**HISTORIC DOWNTOWN ADVISORY COMMISSION**  
Village Green Municipal Building, Council Chambers  
47 Hall Street  
Tuesday, April 28, 2015  
6:15 P.M.

## 1. ARCHITECTURAL REVIEW

Applicant: Sean Snyder  
Location: Lincoln Street  
Existing Zoning: DB, Downtown Business District  
Request: To review a final development plan for a proposed two building office development on 1.05 acres at the request of the Planning and Zoning Commission.

Roofs (PAG, P. 285)

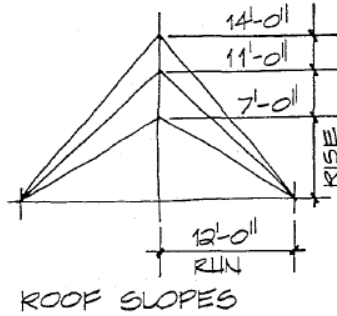
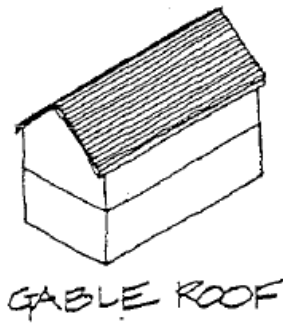
- The roof is consistent with the PAG. However, staff defers to the Architectural Advisor regarding slope.
  - For the larger building, the applicant is proposing a gable roof with a pitch of 12/4 for the main block of the building and 12/10 for the secondary block.
  - For the smaller building, the applicant is proposing a gable roof with a pitch of 12/5 for the main block of the building and 12/10 for the secondary block.
  - Gable roofs are most appropriate for new construction in the Historic District.
    - Based on PAG, the shape of the proposed building has an appropriate mass broken up by the porch.

## Doors (PAG, P. 317)

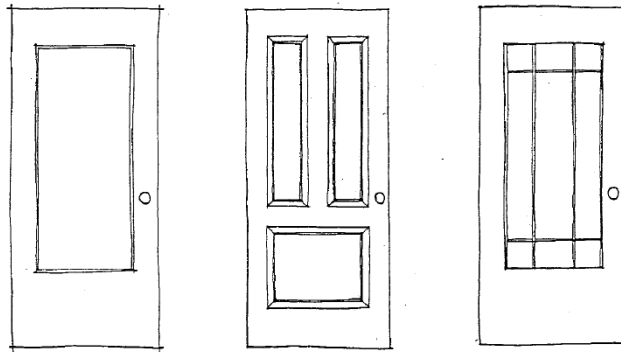
- The applicant's doors are in line with some of PAG recommendations.
  - Although wood doors are preferred, steel doors may be appropriate for replacement or new construction.
    - Staff defers to the Architectural Advisor for an opinion on the details of the door.
  - The PAG does not have guidelines regarding garage doors.
    - Staff defers to the Architectural Advisor for an opinion on the garage doors.

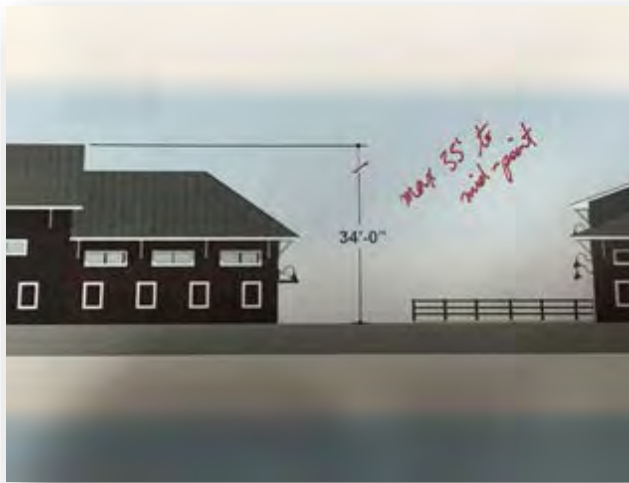
5. To alleviate any concerns about height and scale, the applicant provided a cross section of Lincoln Street to show how the proposed buildings are in relation with neighboring buildings. As can be seen from the figure below, the proposed building would be in scale with the nearby buildings heights.

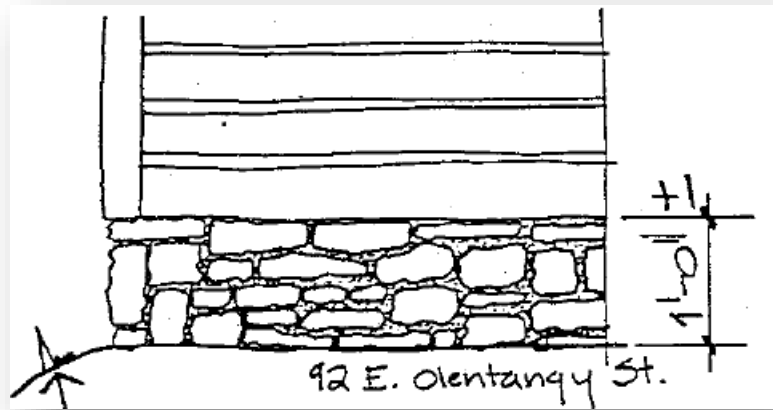
7. The applicant provided turning radius analyses for 40 and 53 foot trucks. To do a rough analysis, staff took the diagrams and superimposed them onto aerial imagery using GIS (the images are attached). Staff, along with the Acting City Engineer did a cursory examination of the images and determined the following:

- a. The Lincoln Street sides at West Olentangy Street will need to be improved to accommodate truck traffic. Improvements would include widening the throat and radius, moving the sidewalk back, possibly relocating the utility pole and restriping. Further details would be determined at a later date by the City Engineer if the plan were to be approved.

- b. A "Semis no right turn" sign will need to be installed to restrict turning onto Lincoln Street for westbound trucks.
  - c. Staff also determined that in the long-term, Lincoln Street may need to be widened and improved due to increased traffic and the development of the adjacent sites to the west and east and south of the subject site. At this time, however, the improvements are not necessary. Since this parcel is in the TIF district, if approved, the property development will increase the TIF fund that could ultimately be used to make the improvements. The neighboring vacant sites, when improved, would also pay into the TIF fund, which would

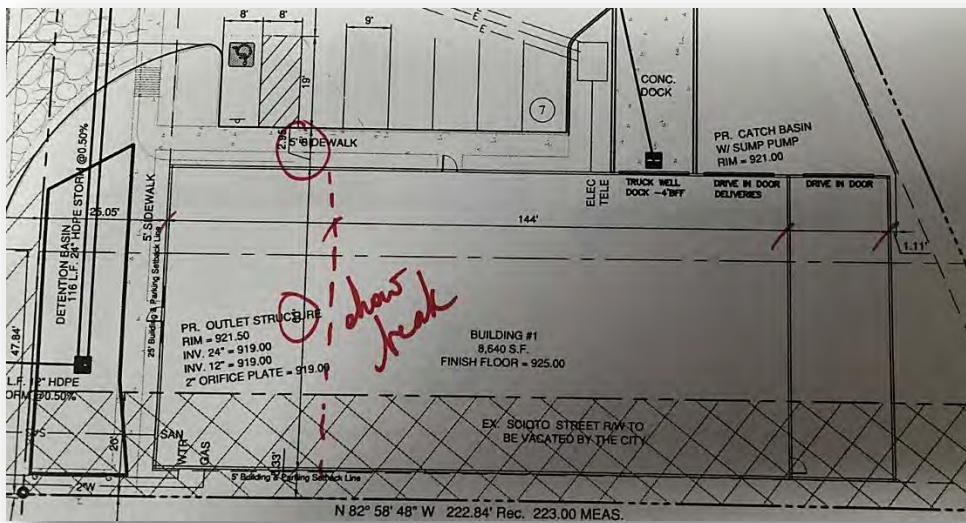
8. The applicant provided additional elevations for Building #1. After reviewing the new architectural drawing staff has the following comments:
  - a. The window style may need to be changed. As per the Architectural Guidelines, double hung windows with no grids are preferred. Also, the dimension of the windows may be incorrect. Dimensions of windows should also be reviewed in the Architectural Guidelines.
  - b. Staff suggests adding a small, stone veneer foundation to the bottom of each proposed building. Stone foundations are typical for barns, the style these buildings are aiming to mimic (see example below).

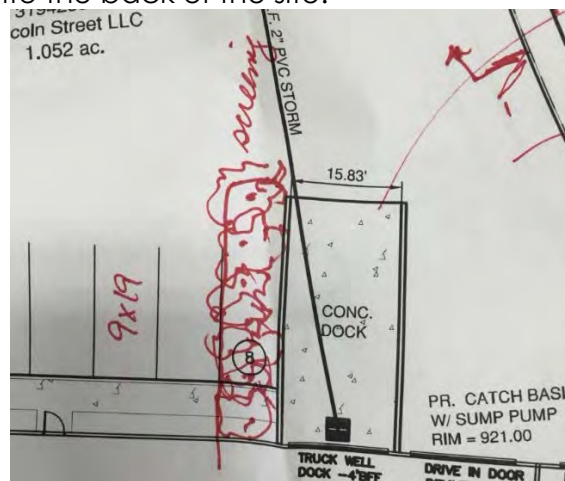
1. The number of parking spaces is insufficient. The applicant used *warehouse* parking requirements (1 parking spot per employee) in their calculations however, the appropriate requirement is for *office use* (1 parking space per 200 square feet). As a result, the site requires a total of 15 parking spaces, not 11. Staff suggests putting additional parking spaces along the back of the site (see below).

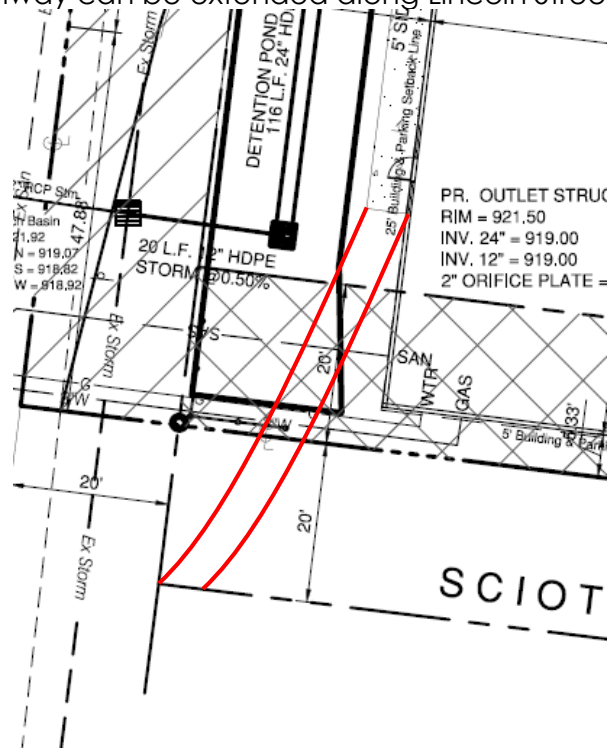
2. The loading dock needs to be screened. Staff suggest removed a parking space and using the space to screen the loading dock (see below). The removed parking spot could also be added to the back of the site. Staff determined that the 4 spaces above and the 1 space here could easily be fit into the back of the site.

FIGURE 2 – ALTA Survey

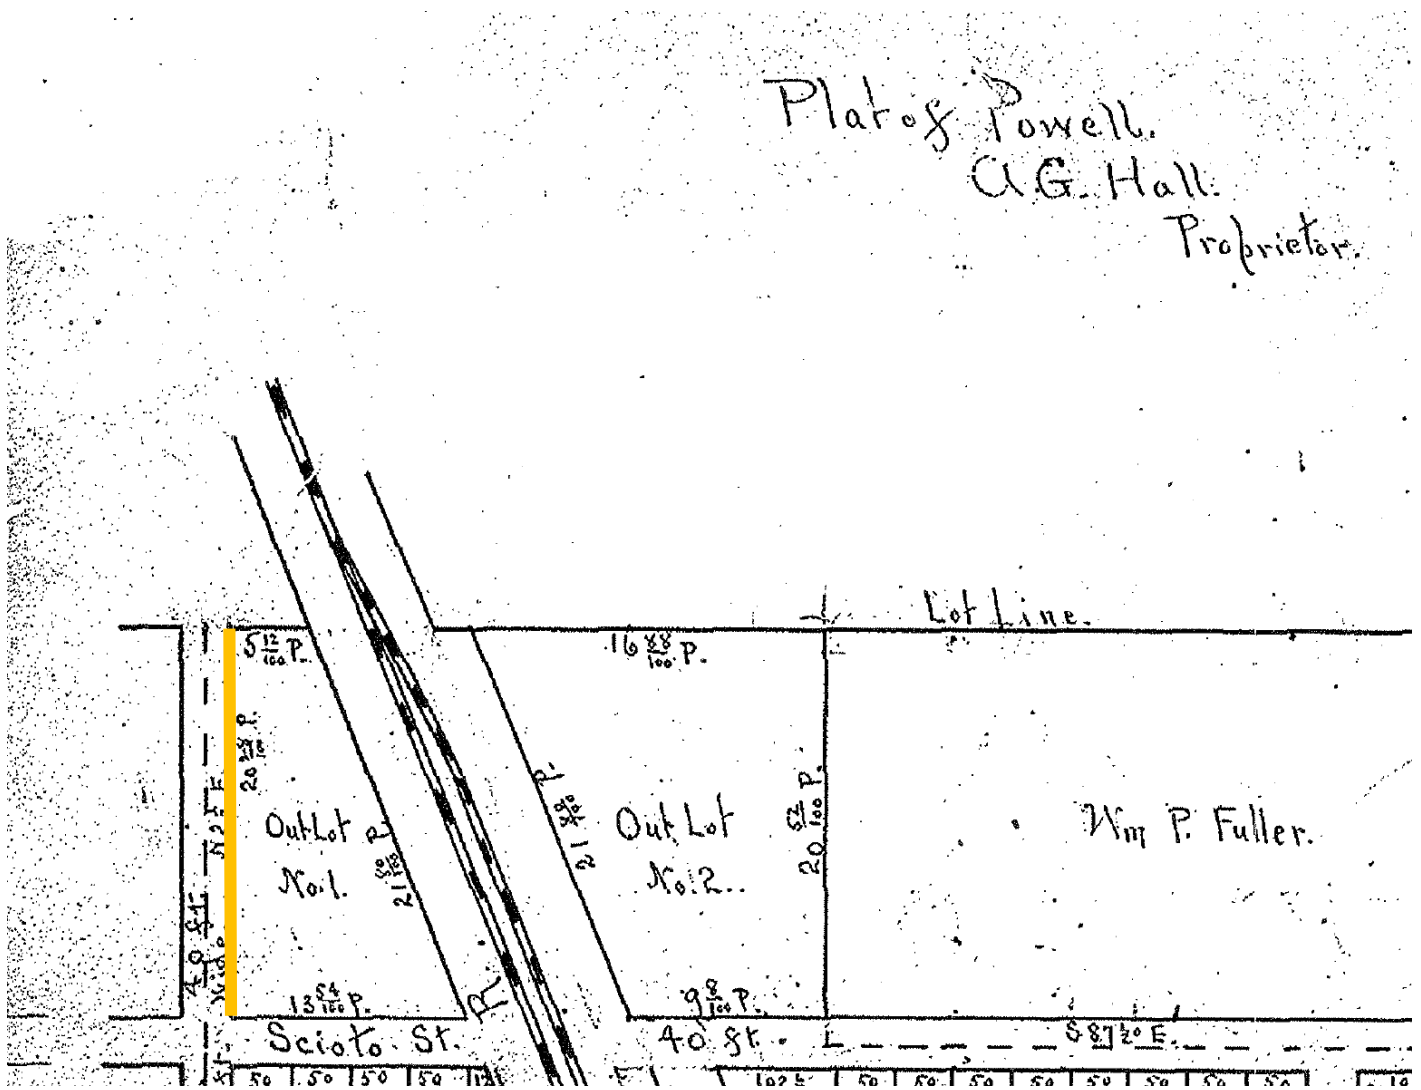
The proposed development is located in the Downtown Business District. Staff reviewed the rules and regulations of the Downtown Business District and found that the development is generally in line with its requirements. There is however, an issue with the survey as presented. Currently the survey may incorrectly show the property edge of the site at the road centerline (see Figure 2, see blue line). Staff did some research and found that the property line may actually be further back at the edge of the right-of-way (Figure 2, see orange line). Staff will need a correct survey to determine the appropriate setback requirements. As of now, Staff assumes the 20 foot setback requirement from the edge of the right-of-way line (Figure 3, see red line), which would then require the applicant to receive a front yard setback variance. Nevertheless, this can be determined at the preliminary development plan stage of review.
